ITEM REPORT PLANNING AND ZONING COMMISSION

REQUEST: **PUBLIC HEARING. Preliminary and Final Plat** to allow “Timberline Heights Second Addition” to create one buildable lot; **Comprehensive Plan Amendment** from Public/Semi-Public/Institutional to High Density Residential; **Rezoning** from OS, Office Service to R-3, High Density Residential; and **Variances** for front yard setback and roof pitch for a 60-unit Apartment for property located at the southwest corner of Clearwater Road and Forest Drive (City File # 2026-023)

APPLICANT: Kuepers Inc.

Existing Future Land Use

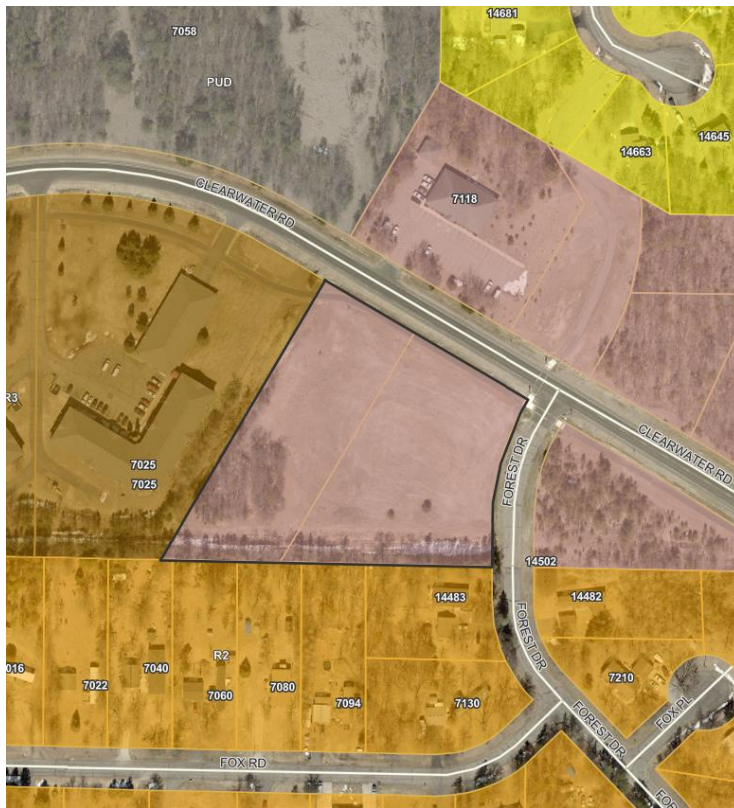
The applicant is requesting a Comprehensive Plan amendment to re-designate the underlying land use guidance for the east side of the site from Public/Semi-Public/Institutional to High Density Residential. As you can see from the Existing Future Land Use Plan below, the westerly lot of the site is already guided High Density Residential. The Public/Semi-Public/Institutional guiding was established at a time when the city was holding this property for a potential fire station, which is no longer planned.

The existing Future Land Use Plan includes a large block of high-density residential land use on the south side of Clearwater Road. The amendment would complete this block from Grand Oaks Drive to Forest Drive as High Density Residential. Future Land Use to the North and East is Office and High Density. This land use would transition across the site to medium density and low density to the south, southeast and southwest.
